HISTORIC AND DESIGN REVIEW COMMISSION

May 15, 2019

HDRC CASE NO: 2019-243
ADDRESS: 2218 W MAGNOLIA AVE
LEGAL DESCRIPTION: NCB 6829 BLK 0 LOT 19
ZONING: R-6, H
CITY COUNCIL DIST.: 7
DISTRICT: Monticello Park Historic District
APPLICANT: Rufino Hernandez
OWNER: Rufino Hernandez
TYPE OF WORK: Exterior modifications
APPLICATION RECEIVED: April 29, 2019
60-DAY REVIEW: June 28, 2019
CASE MANAGER: Huy Pham

2218 West Magnolia
Historic Home Facade Renovation

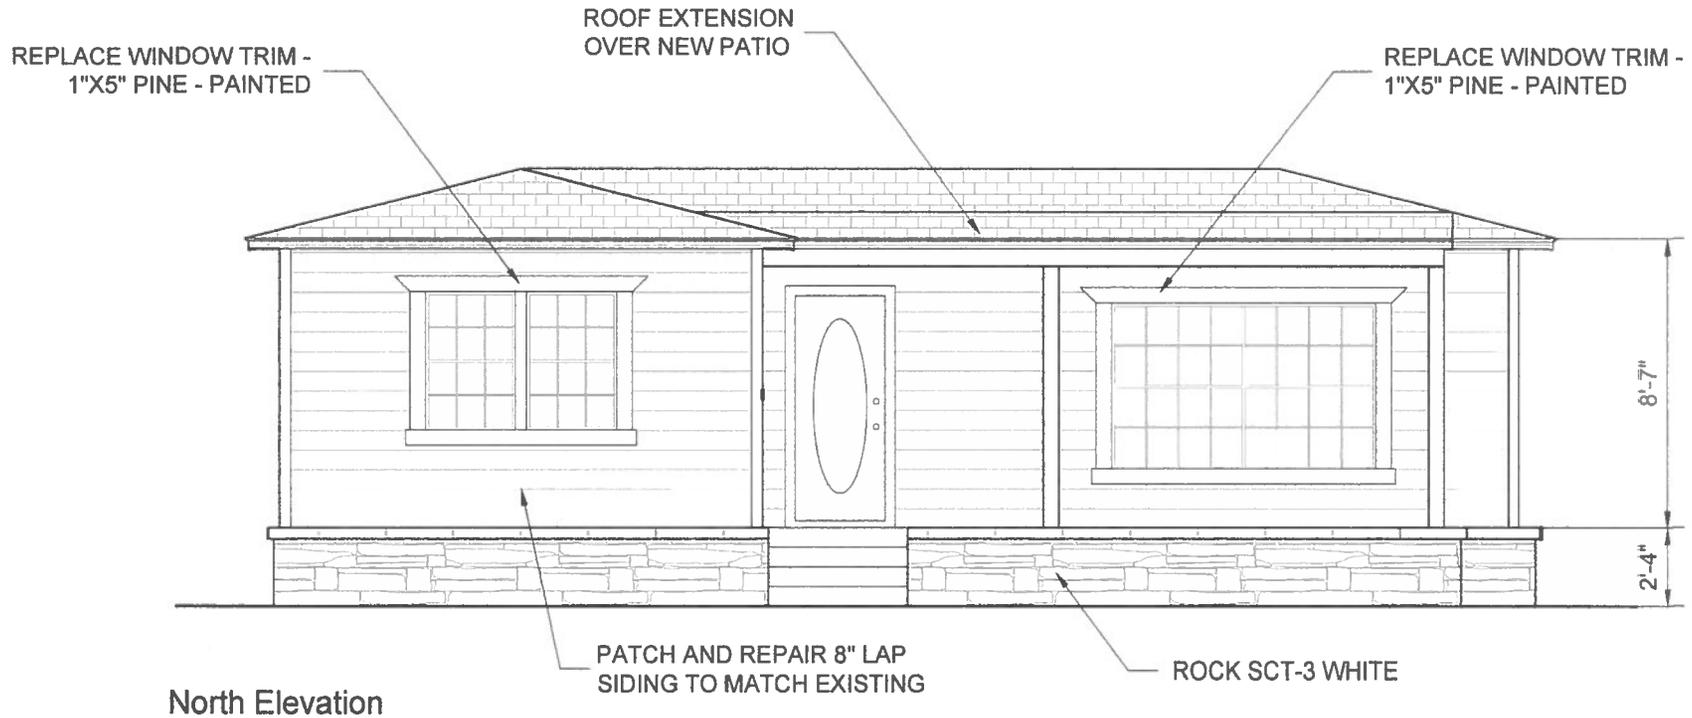
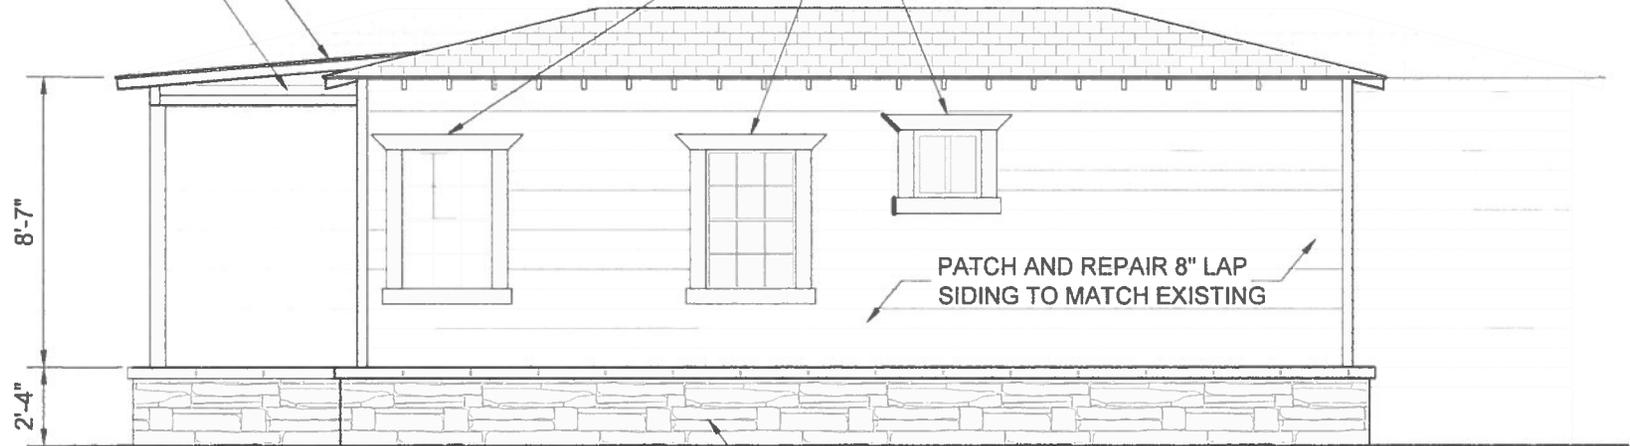
- d. **PORCH INSTALLATION** – The applicant has proposed to install a full width wood porch including shed roof cover over the existing concrete steps. The proposed porch features 2” by 6” members running parallel to the front

façade plane and square wood columns. Per the Guidelines for Exterior Maintenance and Alterations 7.B.v., porches should be reconstructed based on accurate evidence of the original, such as photographs; if no such evidence exists, the design should be based on the architectural style of the building and historic patterns. Staff finds that the structure did not originally feature a porch and that the proposed porch is atypical for a structure of this style. Staff finds that the porch should be removed and the original concrete steps restored.

- e. SKIRTING MODIFICATIONS – The applicant has proposed to install limestone skirting throughout the structure. Per the Guidelines for Exterior Maintenance and Alterations 8.B.i., replacement skirting should consist of durable, proven materials, and should either match the existing siding or be applied to have minimal visual impact. Staff finds that the limestone skirting is a major departure from the minimal traditional style and should be removed. The structure should feature the simple exposed concrete skirting. Smooth Hardie plank with no faux wood grade may be installed at grade to prevent water infiltration.

- f. WINDOW TRIM – The applicant has proposed to replace the simple square window trim with a flared Craftsman style trim on all window through the structure. Per the Guidelines for Exterior Maintenance and Alterations 6.B.iv., window details should only be replaced in-kind when deteriorated beyond repair. Staff finds that the Craftsman detail is a departure from the minimal traditional style structure and should be reversed.

Staff does not recommend approval of items 1 through 5 based on findings a through k. Staff recommends the applicant return the modified elements to their original condition and address the accessory structure's inconsistencies with the Guidelines.

2218 West Magnolia
Accessory Dwelling Unit

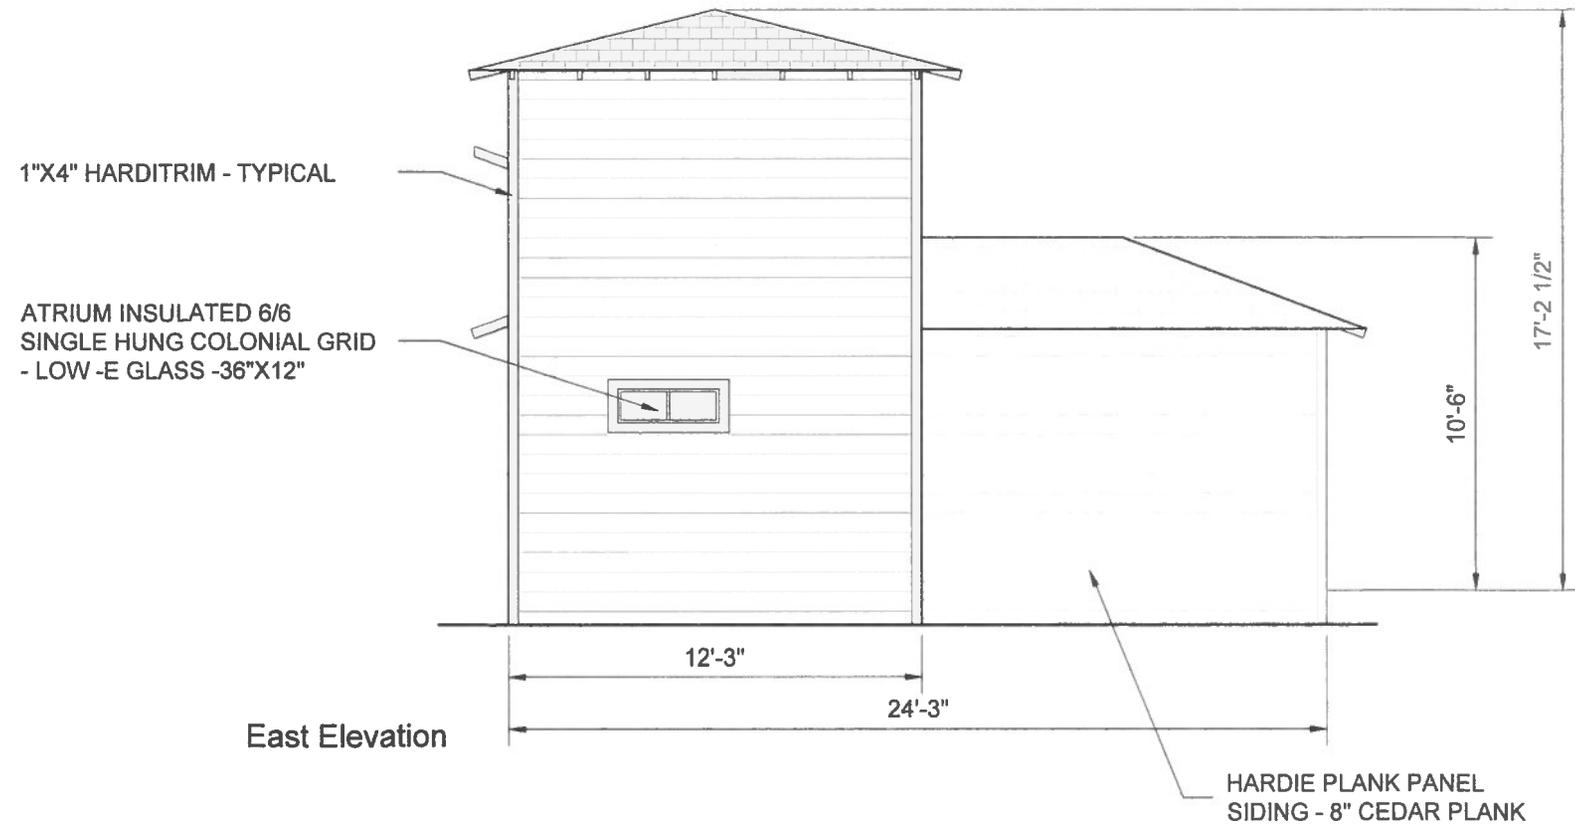
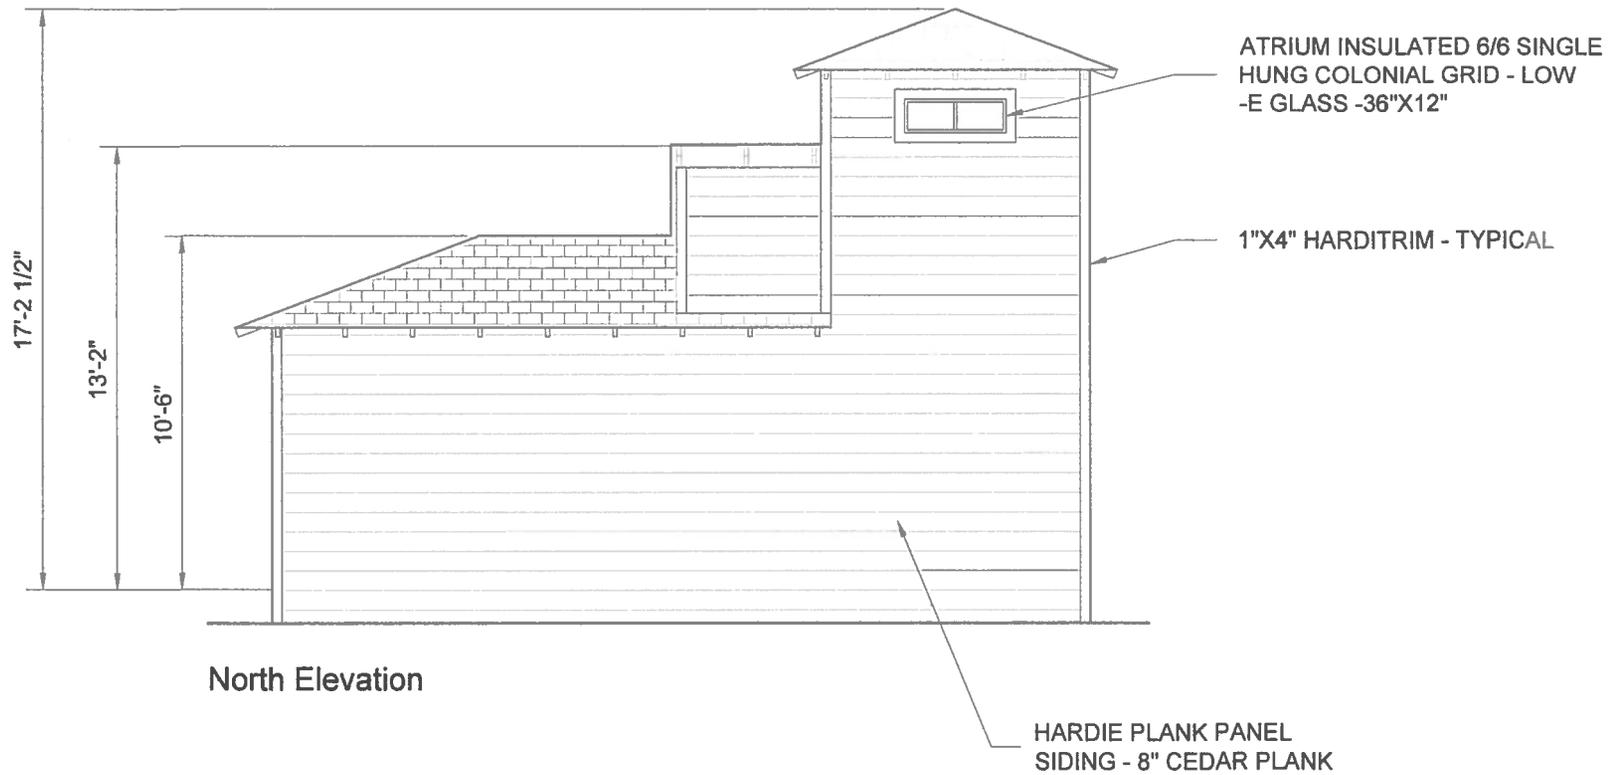
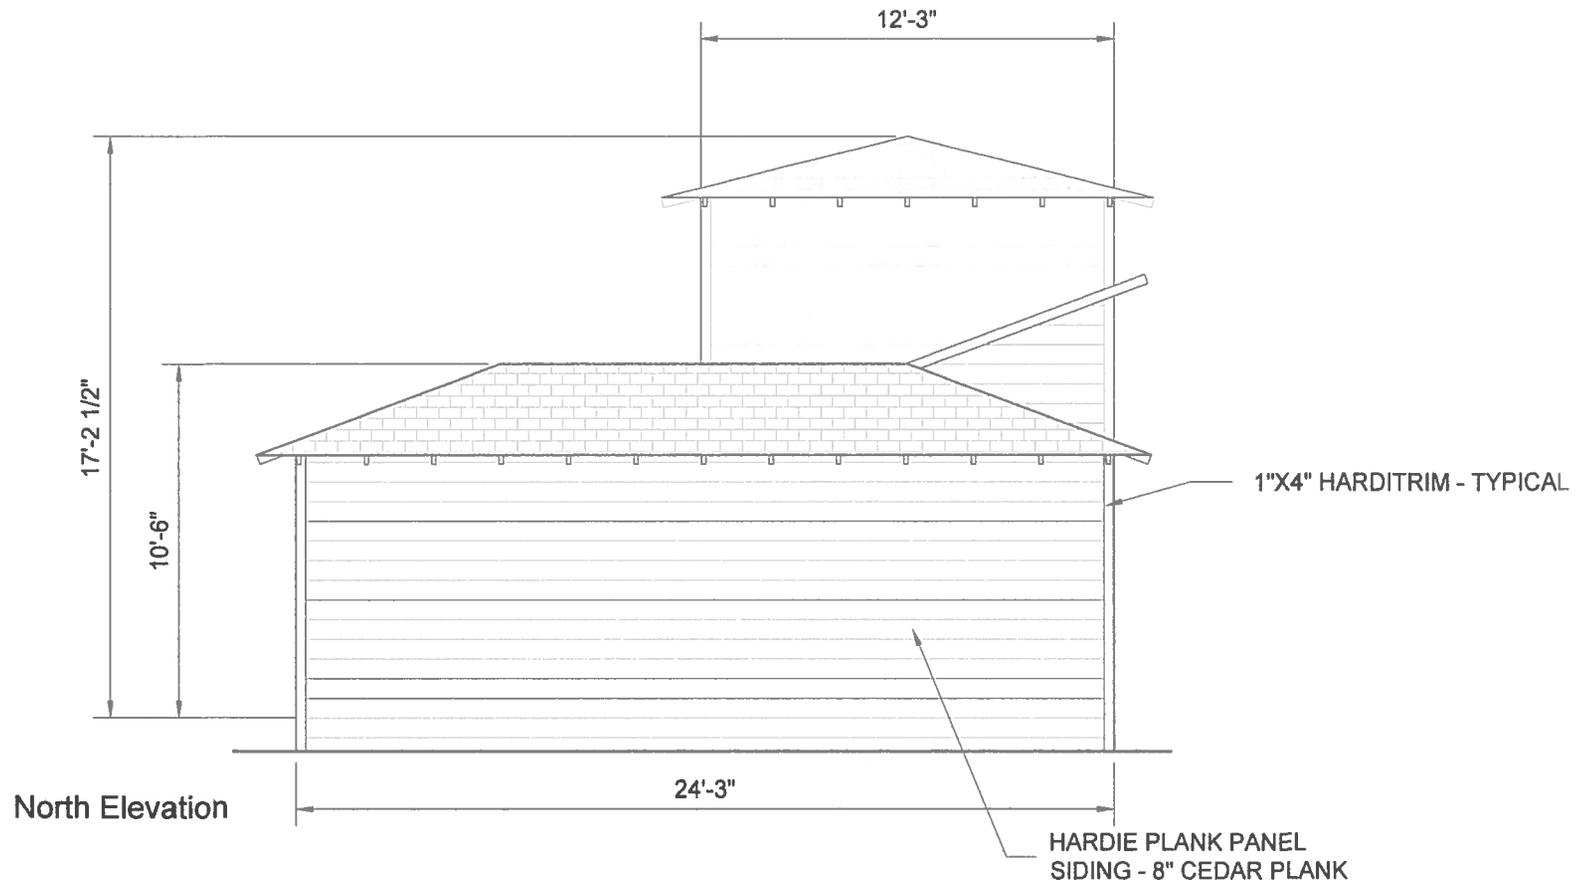
- g. REAR ACCESSORY STRUCTURE – The applicant has proposed to construct a 532 square foot rear accessory structure featuring a composition shingle roof, Hardie plank siding, five (5) vinyl windows, a nine-light steel door, a L-plan footprint, and a two-story square tower element.

- h. ACCESSORY MASSING, FORM, AND SIZE – The proposed accessory structure features an L-plan with one portion featuring a two-story square tower element. The structure also includes a variety of roof forms and heights: the first floor front-facing hipped roof turns to a shed roof before meeting the second-floor pyramid roof of the tower element. Per the Guidelines for New Construction 5.A.i., new garages and outbuildings should be visually subordinate to the principal historic structure in terms of their height, massing, and form. Staff finds that the two-story tower element of the accessory structure to be generally appropriate provided it is located at the rear of the lot and is minimally visible from the public right of way.

- i. ACCESSORY CHARACTER AND DESIGN – Per the Guidelines for New Construction 5.A.iii., new garages and outbuildings should relate to the period of construction of the principal building on the lot through the use of complementary materials and simplified architectural details. Excluding the use of composition shingles, divided light of windows, and lap siding, staff finds that the multiple roof forms, footprint, fenestration details regarding vinyl window size and configuration, door styles, and general massing is a major departure from the minimal tradition primary historic structure.

- j. ACCESSORY DOORS AND WINDOWS – Per the Guidelines for New Construction 5.A.iv., window and door openings should be similar to those found on historic garages or outbuildings in the district or on the principle historic structure in terms of their spacing and proportions. Staff finds that the use of square windows and sliding horizontal windows, the two different door styles, and the general spacing of fenestration elements to be a major departure from historic garages and outbuildings in the district and the minimal traditional primary historic structure. Additionally, staff finds that accessory structure windows should relate to the primary structure by featuring wood or aluminum-clad wood with exterior divided light details matching in trim and the standard stipulations: *Meeting rails that are no taller than 1.25” and stiles no wider than 2.25”. White manufacturer’s color is not allowed, and color selection must be presented to staff. There should be a minimum of two inches in depth between the front face of the window trim and the front face of the top window sash. This must be accomplished by recessing the window sufficiently within the opening or with the installation of additional window trim to add thickness. Window trim must feature traditional dimensions and an architecturally appropriate sill detail. Window track components must be painted to match the window trim or concealed by a wood window screen set within the opening.* The two doors should match and feature a simple, 6-panel wood design or one relating to the minimal traditional style without ornamental glazing or faux divided lights.

- k. ACCESSORY ORIENTATION AND SETBACKS – Per the Guidelines for New Construction 5.B.ii., new accessory structure should utilize the historic setback pattern of similar structures along the streetscape or district for new garages and outbuildings; historic garages and outbuildings are most typically located at the rear of the lot, behind the principal building. In some instances, historic setbacks are not consistent with UDC requirements and a variance may be required. The applicant has proposed to construct the accessory structure in the rear corner of the property with a 5-foot setback line. Staff finds that the generally orientation and setback is consistent with the guidelines and existing accessory structure on E Magnolia. However, the applicant is responsible for complying with all UDC requirements for setbacks and obtaining a variance if necessary.
